**HISTORIC PRESERVATION BOARD
DESIGN REVIEW COMMITTEE
STAFF REPORT
January 24, 2019**

Project #	HPB19-006
Project Type	New Construction
Property Address	322, 324, & 325 S. Lake Avenue and 810 E. Lime Street
Historic District; FMSF#	East Lake Morton Historic District; N/A
Owner/Applicant	Lake Lime LLC / Mr. Steve Boyington and Ms. Erica Craig, WMB-ROI, Inc.
Zoning; Context District; SPI; Future Land Use	MF-22; Urban Neighborhood; Garden District SPI; Residential High
Existing Use	Vacant
Adjacent Properties	Residential
Previous Approvals	3/17/2006 (2006-060) - New Construction of an 8-Unit Multi-Family Building; This project was not realized due to the economic downturn beginning in 2007. 7/27/2017 (HPB17-114) Demolition and New Construction of a Single-Family House; Rehabilitation of existing house was determined infeasible and house was demolished in 2017; plan for new single-family house did not materialize.

The Applicants request Conceptual Approval for the construction of a new 90-unit residential apartment complex consisting of two three-story buildings and associated off-street parking lots on the subject properties.

DWG TITLE:
 PRELIMINARY PROPERTY
 CONCEPT

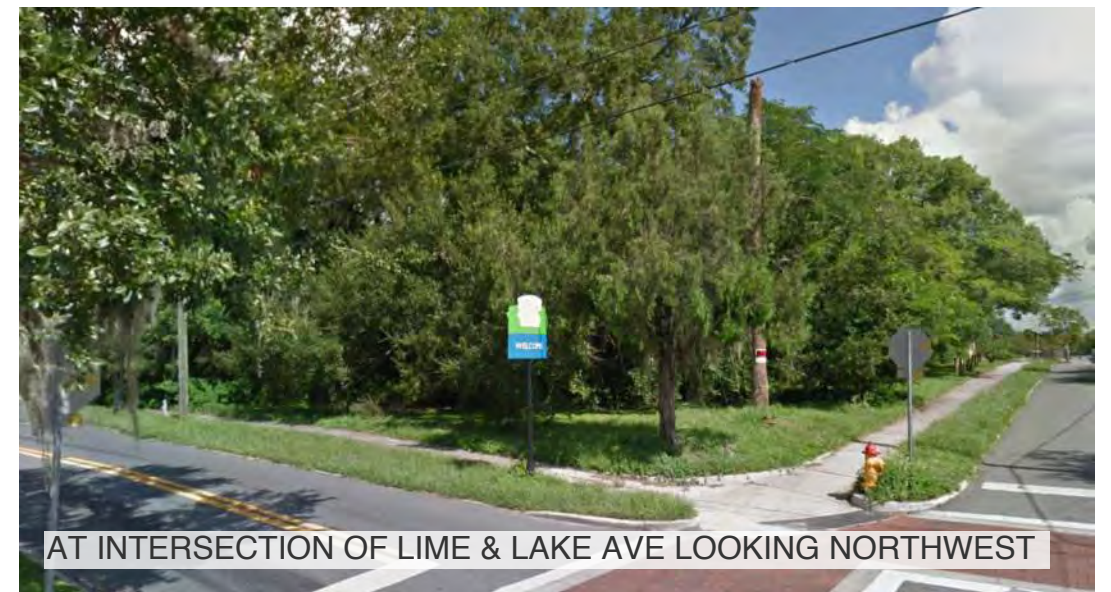
Setback dimensions were not shown on the submitted site plan, but appear to meet the setbacks required by the property’s MF-22/Urban Neighborhood Context District zoning district. The site plan shows a rain garden feature along the street frontages and east elevation of the eastern building.

- The monolithic horizontal massing of the street facing walls reads as flat despite the porches/balconies provided, and is inconsistent with the small scale massing of contributing buildings within the district. Building façades should be articulated to provide recesses and projections, a minimum of three feet in depth, in order to break up this massing and relate to the scale of the surrounding residences.

- The front width of new buildings should be compatible with that of surrounding residences and could be accomplished by pushing out/pulling in façade sections to create the appearance of separate or a series of buildings (the guidelines call for dividing large buildings into smaller elements for compatibility in the district).

- To continue the building pattern and street rhythm of the district, the buildings should be extended further along the S. Lake Avenue frontages. This would also help to hide the surface parking lot on the interior of the site. Alternatively, a decorative knee wall could be used on the S. Lake Avenue frontages, but continuing the building façade to extend the street wall is preferred.

2. Entrance Feature: A distinct public entrance should be provided for both buildings along the E. Lime Street frontage and/or at the corners of S. Lake Avenue to establish compatible orientation toward the primary street and create a pedestrian connection between the building and sidewalk.

- Juliet balconies on the ground floor elevations are not appropriate as they create a visual barrier between the public (sidewalk/street) and private (dwelling units) areas of the building and site; terraces that extend toward the street from the building setback are suggested and provide a transitional zone between these public and private spaces. These balcony features should be limited to second and third floors.

- The gable and rounded parapet details are abstract and postmodern in terms of how they are applied to the roofline. While these details reference elements of historical styles found in the district, they are not integrated as part of a coherent architectural style. The profile of the parapet should be simplified using horizontal parapet features in a consistent style or a modern cornice.

1. To lessen the massing of the buildings, articulate the facades with a minimum offset of three feet in the horizontal plane of street-facing elevations and extend ground floor porches across the rain garden to connect the building to the sidewalk;

2. Create a publicly accessible entrance feature on the E. Lime Street elevations to establish proper orientation for the buildings and create a pedestrian connection to the sidewalk/street.

3. Extend the buildings along S. Lake Avenue frontages or construct a knee wall on these frontages;
4. Remove the Juliet balcony railing from the ground floor units and convert this feature to a patio area;

5. Convert the gable and arch parapet features to a squared profile; a cornice can be used; and
6. Use significant texture, such as brick or rusticated stone, on the ground floor wall cladding to differentiate the base of the building from the smoother textures of the second and third floors.
